## Declaration for an Amendment to the Record of Decision

The purpose of this decision document is to present an amendment to the Record of Decision (ROD) for the Moss-American Site, which is located in Milwaukee, Wisconsin. This decision was reached in accordance with the Comprehensive Environmental Response, Compensation, and Liability Act of 1980 (CERCLA), as amended by the Superfund Amendments and Reauthorization Act of 1986 (SARA) and the National Contingency Plan (NCP).

The ROD amendment for the Moss-American site has three principal components:

1) changes in soil treatment technology, 2) potential changes in cleanup standards, and 3) changes in cover design and requirements.

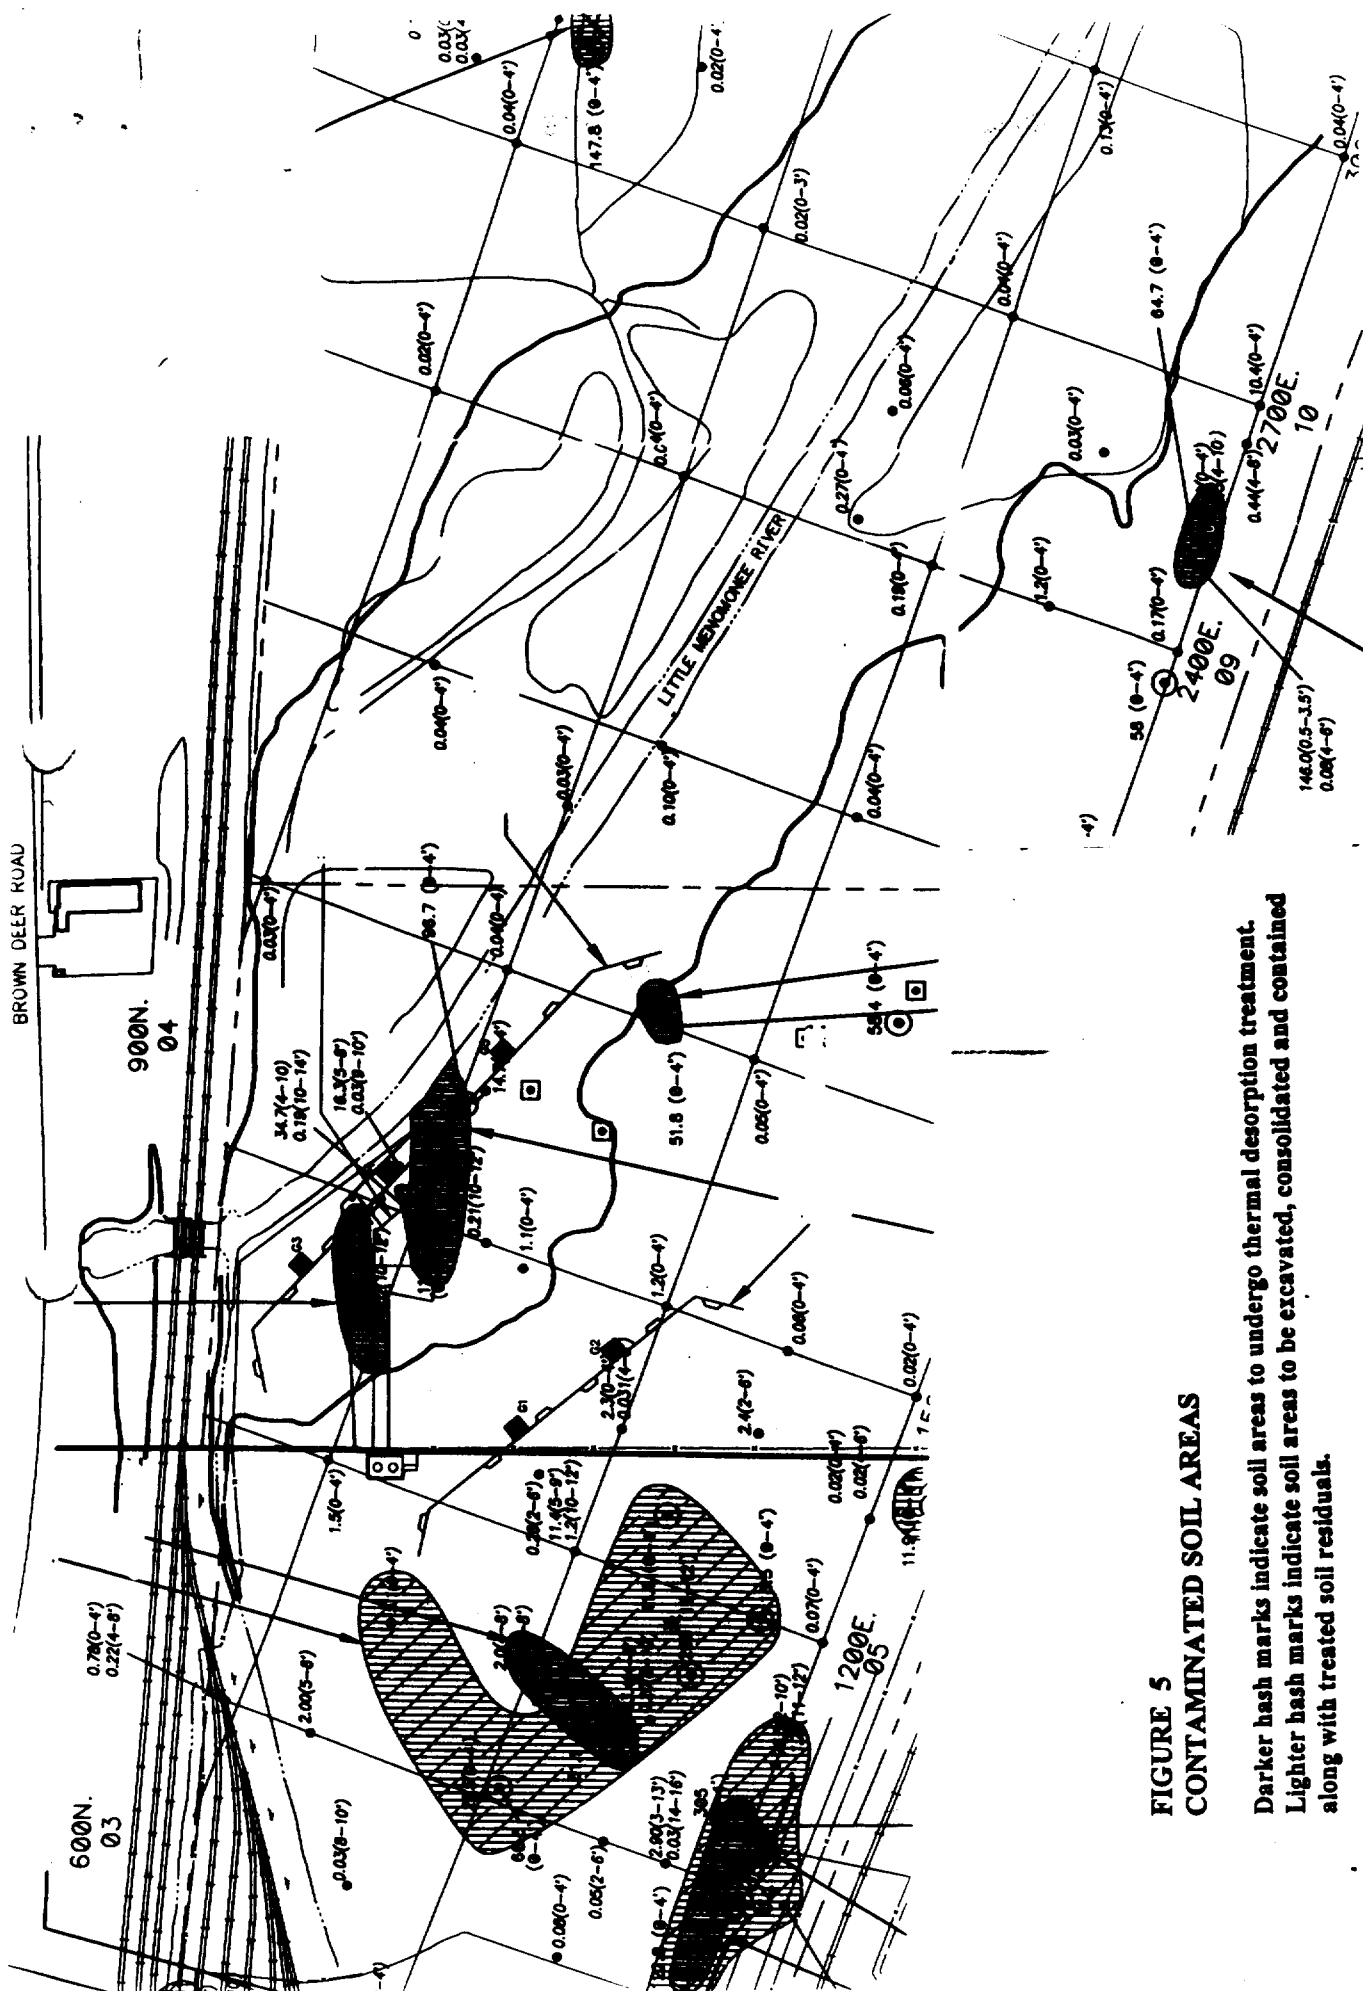
Site soil areas to undergo thermal desorption treatment would be selected for one of three reasons: 1) Direct contact "hot spots" ( $> 78$  mg/kg CPAHs (approximately 78 parts per million (ppm)), 2) groundwater contaminant source areas having the presence of free-product creosote, and 3) soils containing contaminants exceeding Wisconsin generic residual contaminant levels (RCLs) for benzene/toluene/ethyl benzene/xylene (BTEX) and PAHs in soils which pose a source threat in attaining groundwater cleanup goals. It should be noted that these BTEX compounds occur less frequently and at levels well below CPAH compounds. However, such compounds will be considered in an effort to comply with soil cleanup standards developed since the original ROD. Residual contaminant levels (RCLs) in soils of 1.5 ppm for toluene, 2.9 ppm for ethyl benzene, 4.1 ppm for xylene, 5.5 ppb for benzene and for three PAH compounds: 0.4 ppm for naphthalene, 100 ppm for fluorene, and 48 ppm for benzo(a)pyrene are considered to pose no further threat as a source of contaminants to groundwater. Accordingly, U.S. EPA hereby adopts these RCLs for this Site. More darkly shaded areas depicted in Figure 5 indicate areas which may undergo thermal desorption treatment according to discussion in this paragraph, however, this figure may not represent the full aerial extent accurately, so further discrete soil sampling will be necessary to define these areas prior to excavation.

**Darker hash marks indicate soil areas to undergo thermal desorption treatment. Lighter hash marks indicate soil areas to be excavated, consolidated and contained along with treated soil residuals.**

FIGURE 6  
AREAS IN EXCESS OF GROUNDWATER RCL/PAHs

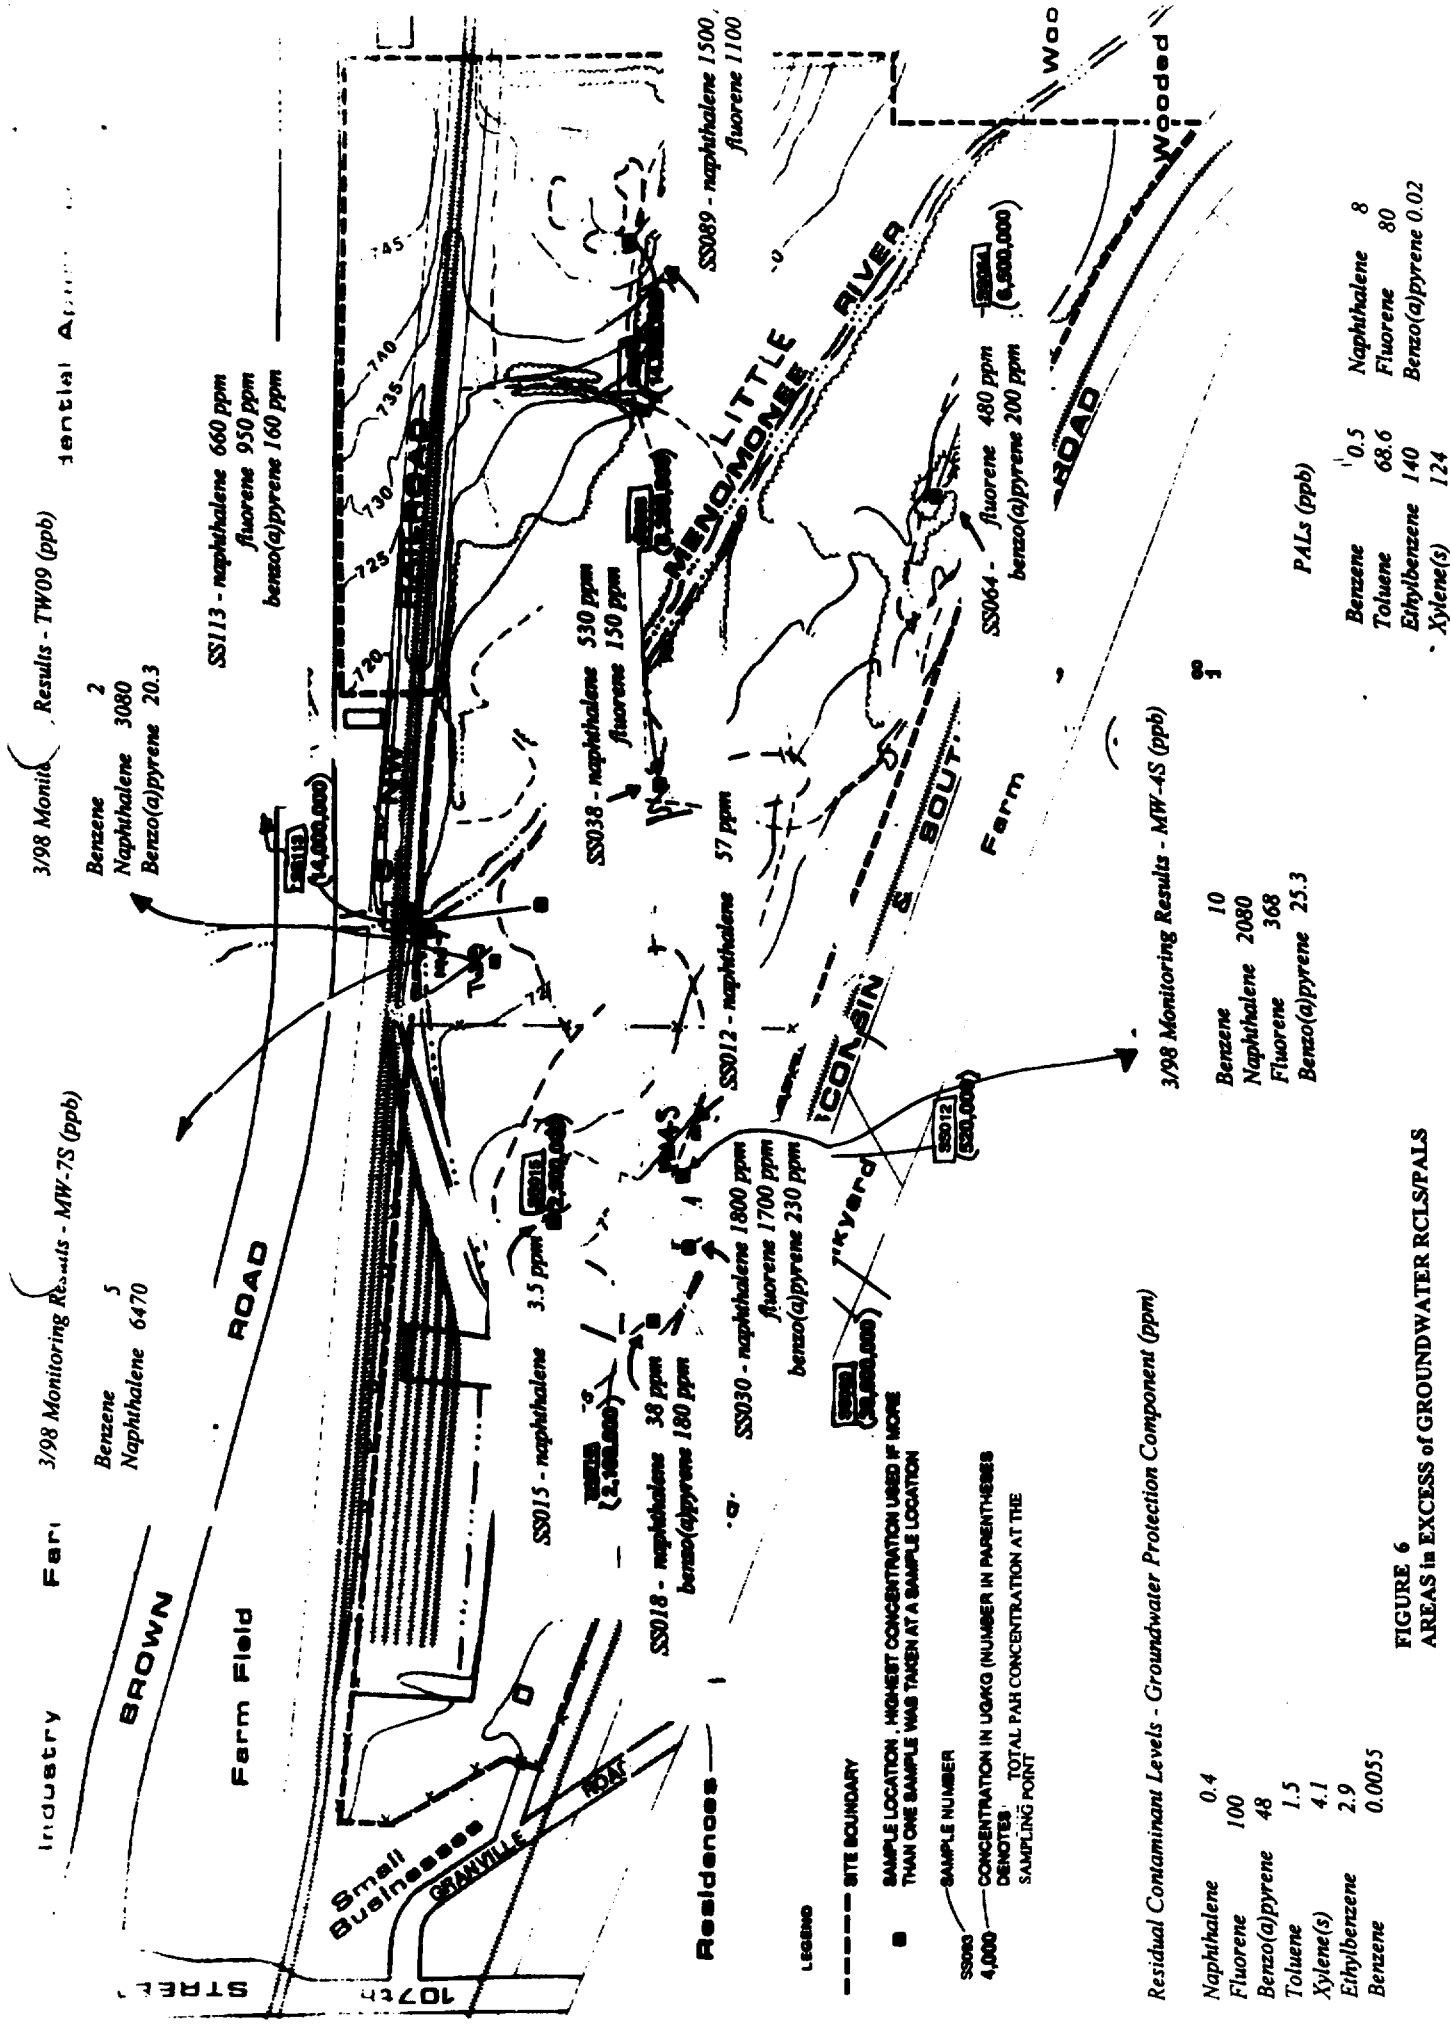
Additionally, it is also appropriate to consider the implications of groundwater monitoring results now being conducted quarterly since the commencement of remedial action work at the site. Results received in June 1998 indicate that while many groundwater monitoring wells at the Moss-American site are relatively free of significant contaminant levels, three wells indicated notable groundwater contamination. These wells are MW-4S, MW-7S, and TW-09. Under NR 140, preventive action limits (PALs) have been established for three PAH compounds - naphthalene (PAL of 8 ppb), fluorene (PAL of 80 ppb), and benzo(a)pyrene (PAL of 0.02 ppb). Naphthalene levels at these three monitoring wells were particularly high, with concentrations of 2080 ppb at MW-4S, 6470 ppb at MW-7S, and 3080 ppb at TW-09. Residual contaminant levels of 0.4 ppm, 100 ppm, and 48 ppm have been established for groundwater protection for naphthalene, fluorene, and benzo(a)pyrene, respectively. U.S. EPA also adopts these RCLs at the Site. In addition to the areas discussed in the previous paragraph as requiring thermal treatment, U.S. EPA makes note of the following points from Remedial Investigation sampling

Approximate location of these points is provided in Figure 6. U.S. EPA notes that there may indeed be some overlap of areas to undergo thermal desorption between Figures 5 and 6. However, further discrete soil sampling should be conducted before treatment occurs in areas of the site that may not have been adequately characterized by past sampling efforts to determine if groundwater RCLs are currently exceeded and after treatment in the excavated areas to ensure that unacceptable threats to groundwater have been successfully addressed through attainment of the groundwater RCL.

Because of the linkage between certain RCLs and PALs, U.S. EPA hereby adopts promulgated PALs for naphthalene, fluorene, and benzo(a)pyrene as supplementary groundwater restoration ARARs in addition to the BTEX compounds previously cited.

**FIGURE 7**  
**FLOODPLAIN PORTION**  
**COUNTY PROPERTY ON**  
**FORMER CREOSOTE SITE**

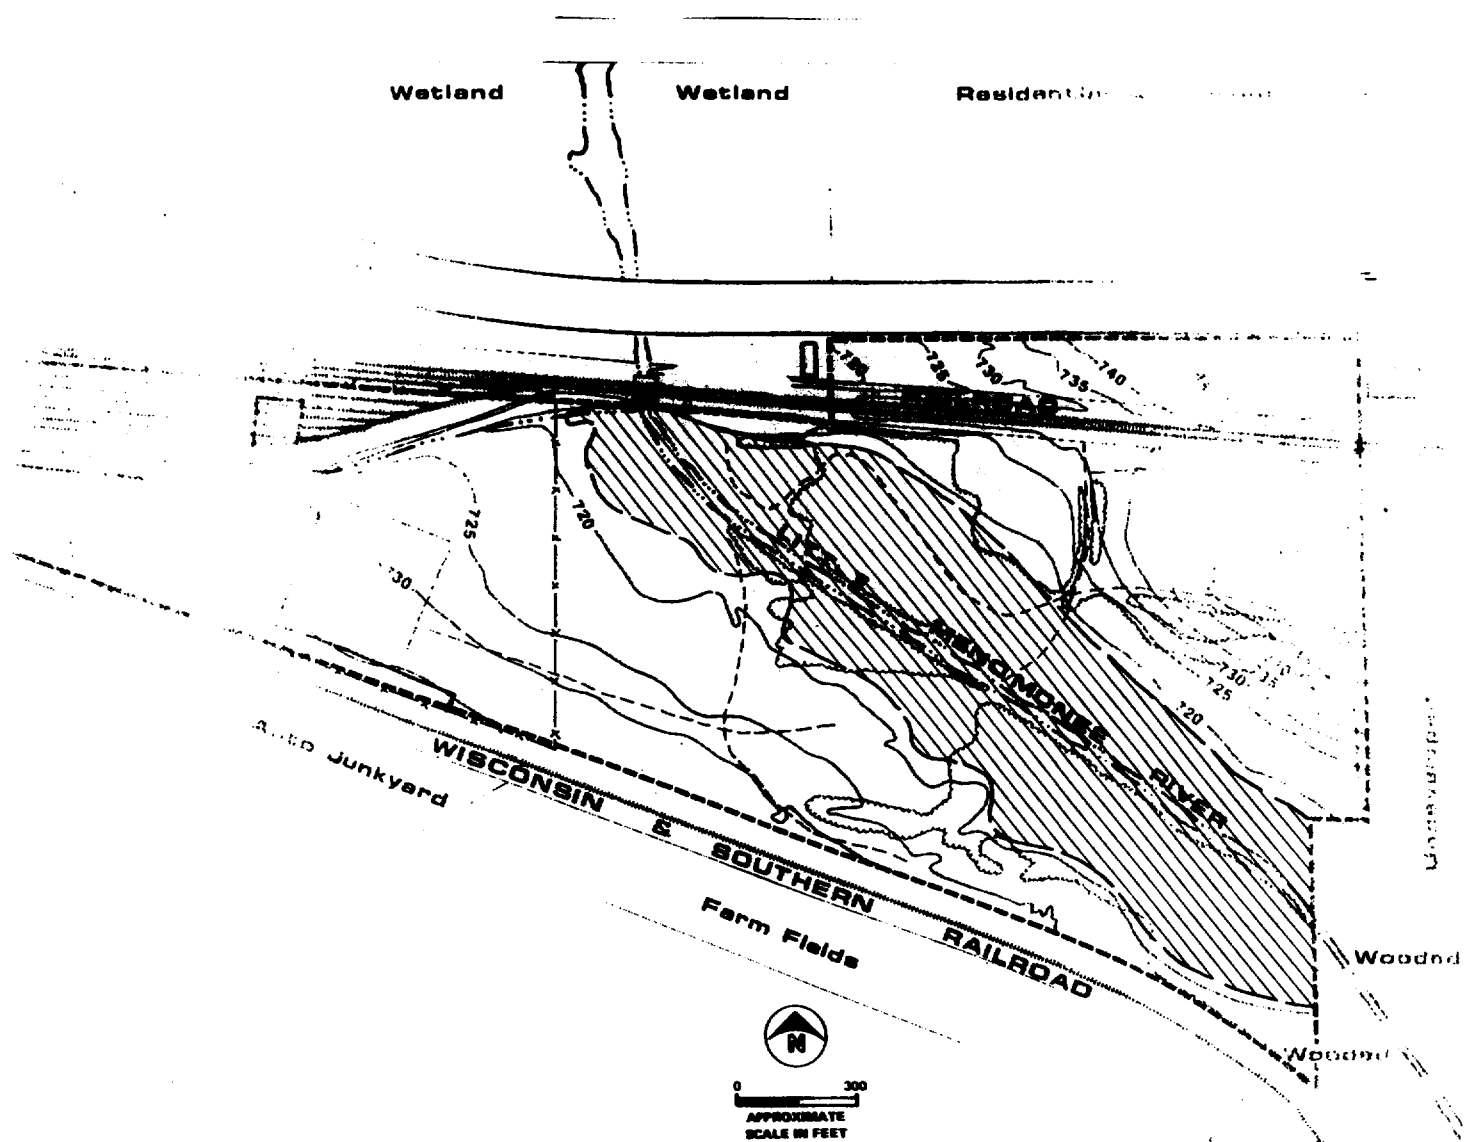
U.S. EPA believes that a dynamic situation exists between the Little Menomonee River and its floodplain. This means that surface soils having excessive CPAH concentrations could be viewed as a possible threat to attainment of sediment quality goals. In the same way, deposition from the river could contaminate the floodplain, and consideration of realistic expectation of post-sediment management remediation must be made concerning any further floodplain remediation. U.S. EPA notes that only a very small portion of the site floodplain is likely to be affected by the current ROD amendment - namely that portion which is also a part of the former wood preservative facility. See Figure 7 in contrast to Figure 2. For this portion of the floodplain, EPA will adopt a removal cleanup level of 15 ppm CPAH if appropriate deed restrictions are secured within 180 days of the effective date of this ROD amendment.

As noted above, a Park and Open Space plan adopted by the County in 1991 which calls for enhanced recreational opportunity in river corridor settings such as the Little Menomonee. For Milwaukee County property which is located in the floodplain of the Little Menomonee River and is a part of the former creosote plant, U.S. EPA believes that a recreational exposure scenario may be applied. This is consistent with the system of parklands and trails maintained by Milwaukee County downstream of the former wood preserving facility. Industrial development is not likely within the floodplain. Applying the procedures in NR 720 to determine a site-specific RCL, a cleanup level of approximately 49 ppm CPAH provides sufficient direct contact protection for the recreational user. However, U.S. EPA will not adopt 49 ppm CPAH as the cleanup value for County-owned floodplain land on the former creosote plant. Chapter NR 720 series requires the soil to surface water pathway be addressed. After considering needed erosion control measures and sediment remediation values, U.S. EPA adopts a figure of 15 ppm CPAH to be the surface water RCL for the entire former creosote plant and the recreational cleanup value for the County owned portion of the site in the floodplain.

Soils in the floodplain under B. that remain in place and exceed the direct contact RCL for recreational usage shall be covered with 2 feet of clean soil and 6 inches of vegetated topsoil, provided appropriate deed restrictions and maintenance agreements are obtained within 180 days after the effective date of this amendment, and provided that the necessary floodplain easements are obtained for filling in the floodplain. If the floodplain easements cannot be obtained, these soils shall be removed so that the remaining soils may not exceed the NR 720 residential direct contact RCL values for all the contaminants of concern. This timeframe may be extended upon the approval of U.S. EPA in consultation with the WDNR.

FIGURE 8

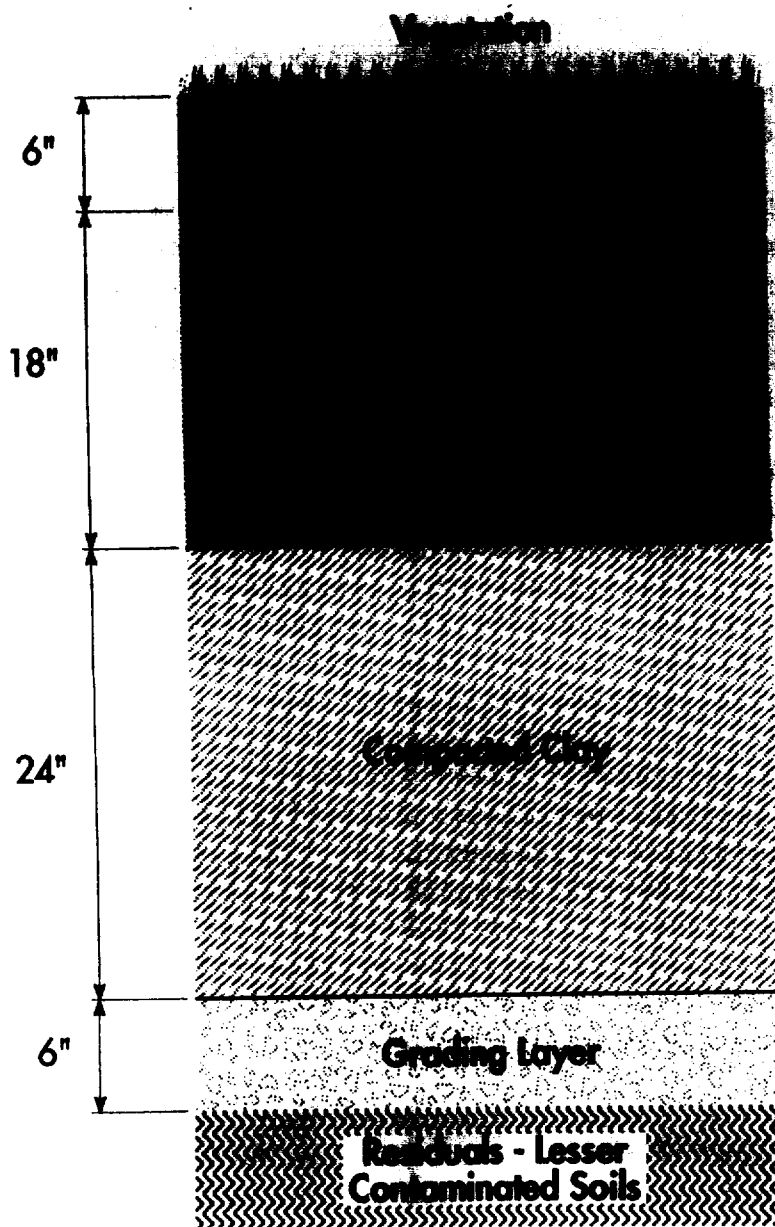
The design of the s. NR 504.07 cover system includes a clay cap (approximately 24 inches thick) topped with a suitable frost-protection soil layer (approximately 18 inches thick) A cross-section of such cover is depicted in Figure 8.

Section NR 504.07 cover (CAMU reconsolidation disposal unit)

**FIGURE 9**  
**ASPHALT PAVED PORTION OF SITE**

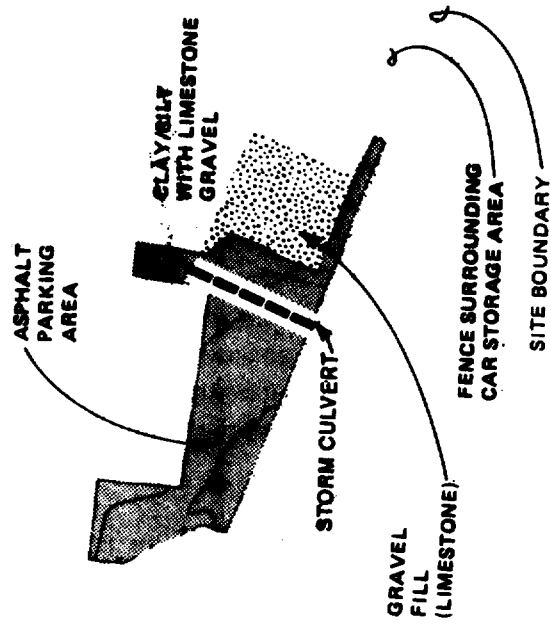
The asphalt cover over portions of Union Pacific property would not constitute a cover complying with either federal or state solid or hazardous waste management rules. However, U.S. EPA is mindful of administrative reforms which seek to promote productive future site utilization. Provided that this material is not excavated and adequate maintenance/repair of asphalt paving can be assured, U.S. EPA will not seek further cover of this material. See Figure 9 for the approximate location of this area. Section NR 720.19(2), Wis. Adm. Code, allows a soil performance standard remedy to be selected in place of a level which complies with an approved RCL. One such example of compliance would be in arranging for permanent engineering control, such as defined asphalt inspection and maintenance schedules, to be established. Should a performance standard for a portion of the site be invoked, a deed restriction must be recorded to prevent activity that would compromise the performance standard, such as excavation. A maintenance agreement is required to assure continuing adequate protectiveness. Section NR 720.19 seems especially pertinent to necessary asphalt maintenance scheduling and to measures which may be taken to control erosion and undue runoff which may interfere with subsequent sediment management goals.

Existing (as of the effective date of this amendment) asphalt pavement or 2 feet of clean soil and 6 inches of vegetated topsoil (NR 720 performance standard covers for in place soils)
